## *Correction to* **Printed-Circuit Board for the FT-817 Panadapter**

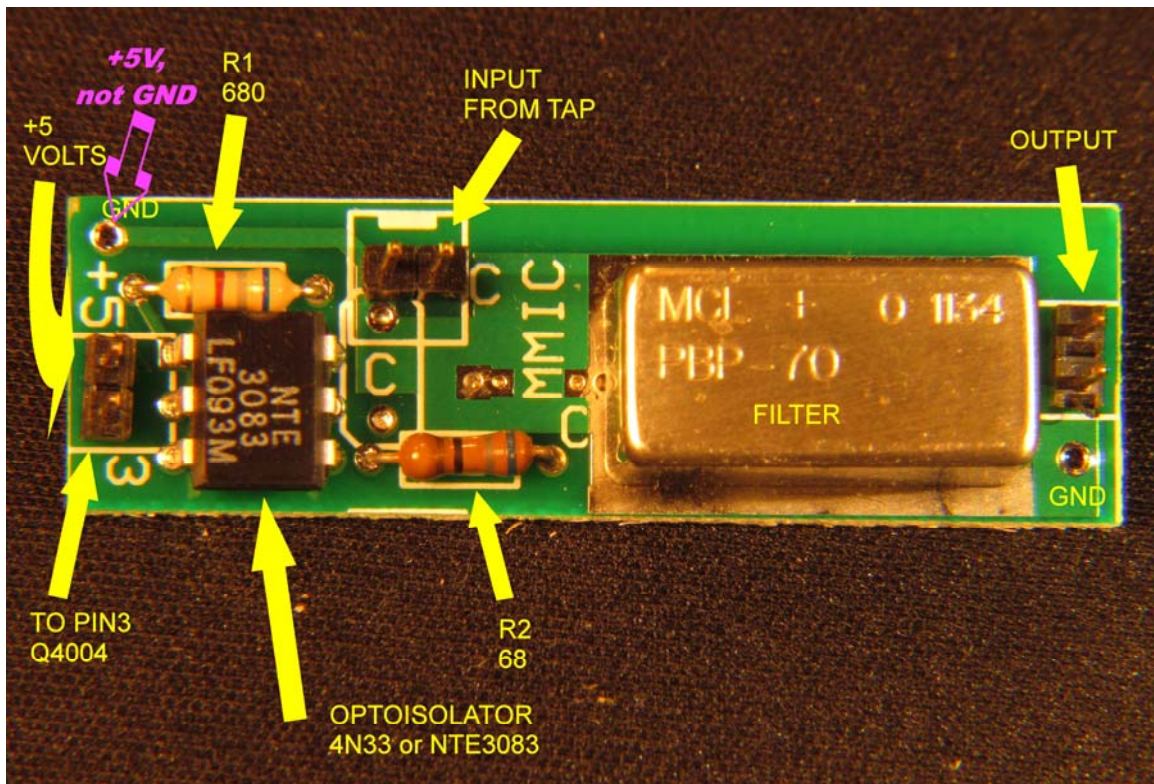
There was an error in the PC board connections shown in Figure 2. The hole in the upper left, marked GND in Figure 2, is actually connected to +5 volts. If you don't connect anything to the hole, it won't matter. GND connections are available at the input and output, and most of the filter pins.
